SERVICE NEWS

CDV-1600, CDV-1100
CDV-1200K, CDV-1000

BULLETIN No. : E-553

Introducing the Improved Durability of Tray Rack Gear

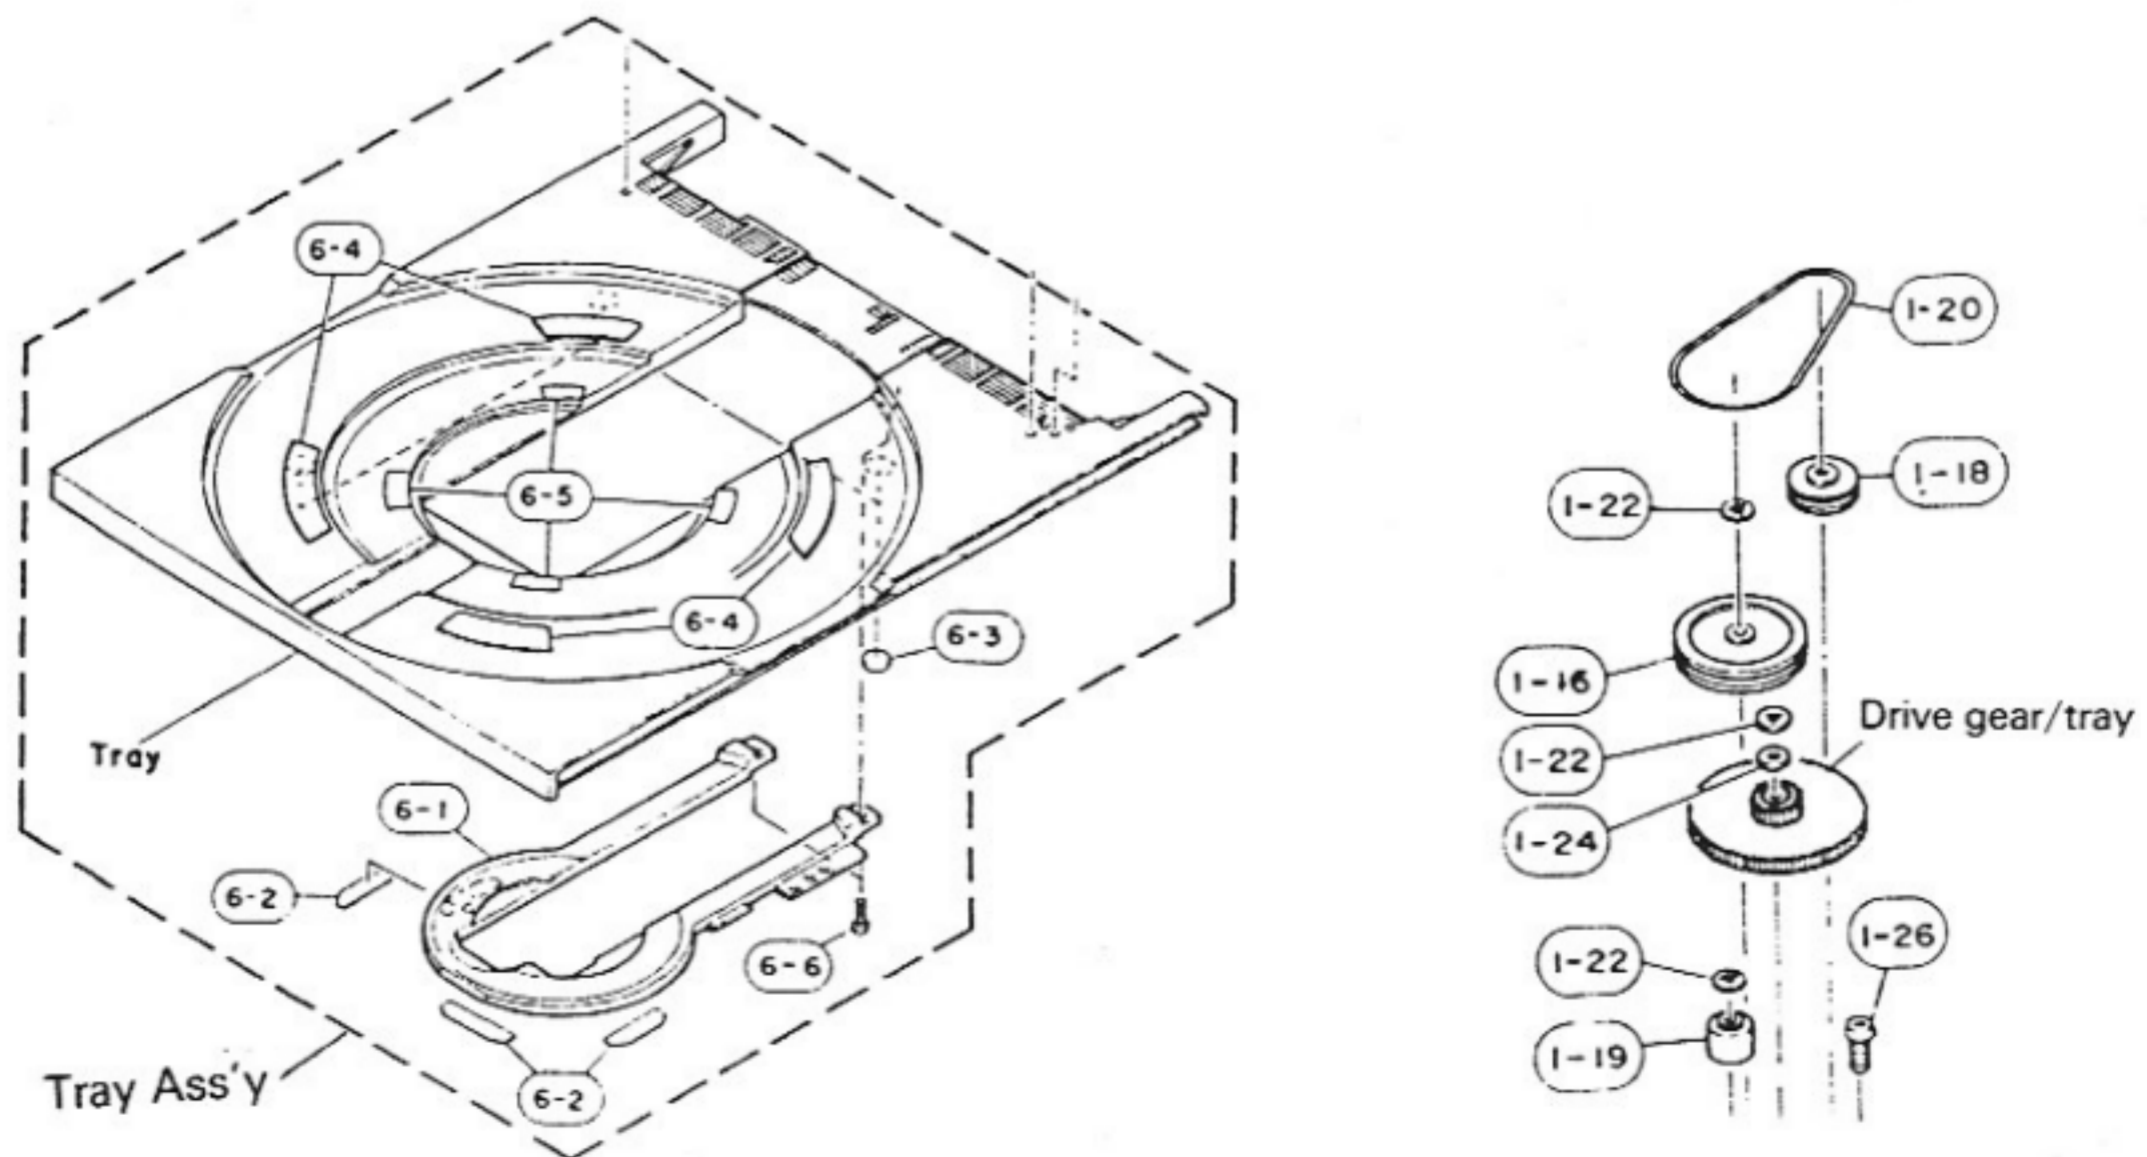
[Purpose] The tray does not open or close smoothly due to the nick or crack of the rack gear. Even when the tray is replaced, this symptom occurs again in one year or so.

[Modification] we have made test production and experiment for durability improvement. As a result, we have come to manufacture the products with durability improved approximately three times.

Note: The difference is the use of plastic materials and the number of gears. So the drive gear/tray must be replaced when the tray assembly is replaced.

Part No.	Description
VL748000	Tray Ass'y
VL748300	Tray Ass'y
VL372200	Gear/tray drive
